# Access Compliance Report

### (Curb Ramps)

Intersection ID: 27363	Main Street: REA_RD	Cross Street: BALLANTYNE_COMMONS_PY	Location: NE
ADA ID: 47DA3B10AFAD	Ramp Type: Perp	Initial Pass/Fail: Fail	Overall Compliance: No
Severity Score: 21.25			
Codes/Mitigation Info/Possible Solution		Field Measurements/Component Compliance

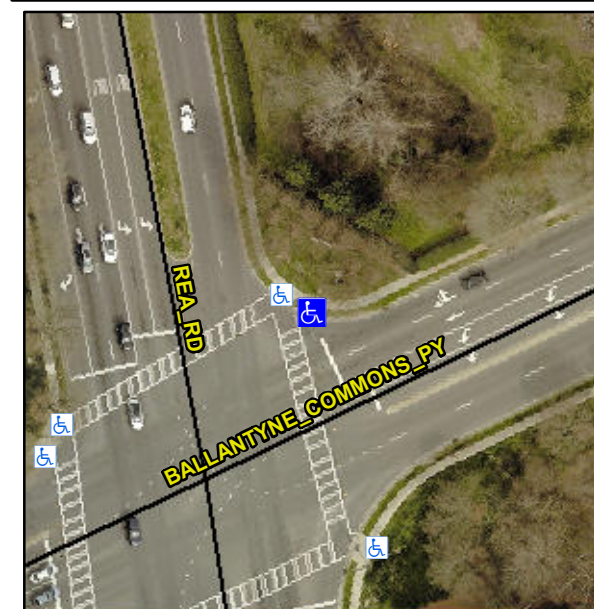
**Not Found, R304.5.1, R304.5.3**

Compliance	Description	Data	Compliance	Description	Data
N/A	Ramp Length (in)	108.0	Yes	Ramp Slope (%)	6.8
No	Ramp Width (in)	43.0	No	Ramp XSlope (%)	5.8
N/A	Flare Type LT	N/A	N/A	Flare Type RT	N/A
N/A	Flare Slope LT (%)	N/A	N/A	Flare Slope RT (%)	N/A
N/A	Flare Traversable LT?	N/A	N/A	Flare Traversable RT?	N/A
N/A	Landing Length (in)	N/A	N/A	DWS Provided?	N/A
N/A	Landing Width (in)	N/A	N/A	DWS Contrast?	N/A
N/A	Landing Slope (%)	N/A	N/A	DWS Length (in)	N/A
N/A	Landing X Slope (%)	N/A	N/A	DWS Full Width?	N/A
N/A	Landing Curb? (Y/N)	N/A	N/A	DWS Offset (in)	N/A
N/A	Shared Landing?	N/A			
N/A	Gutter Ponding?	N/A	N/A	Gutter Slope (%)	N/A
N/A	Gutter Lip Ht (in)	N/A	N/A	Gutter X Slope (%)	N/A
N/A	Painted X Walk1?	Yes	N/A	Painted X Walk2?	N/A
	X Walk 1 Direction	To S		X Walk 2 Direction	N/A
N/A	X Walk 1 Width (in)	120.0	N/A	X Walk 2 Width (in)	N/A
	X Walk 1 Slope (%)	3.8		X Walk 2 Slope (%)	N/A
	X Walk 1 X Slope (%)	0.1		X Walk 2 X Slope (%)	N/A

**Remove & Replace Entire Ramp.  
Restripe Crosswalk.**
